Product Change Notification

Control No. PCN-11111

March 15, 2011

Fig. 1 (a) Top view of eSOP (K) package with the current pin-out configuration.

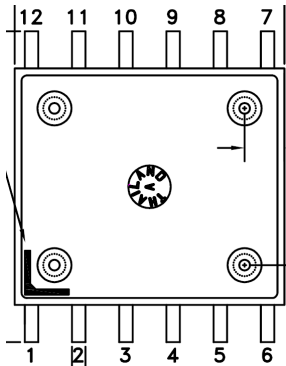
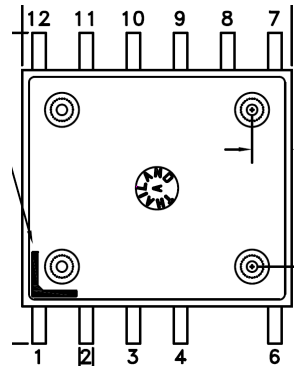
DESCRIPTION OF THE CHANGE: The pin configuration of all products in eDIP and eSOP packages is being modified. The modification is to eliminate an unconnected pin (pin 5) in order to improve creepage between the high-voltage pin (pin 6) and the adjacent pin. See the figures below for illustration of the changes.

Fig. 1 (b) Top view of eSOP (K) package with the new pin-out configuration
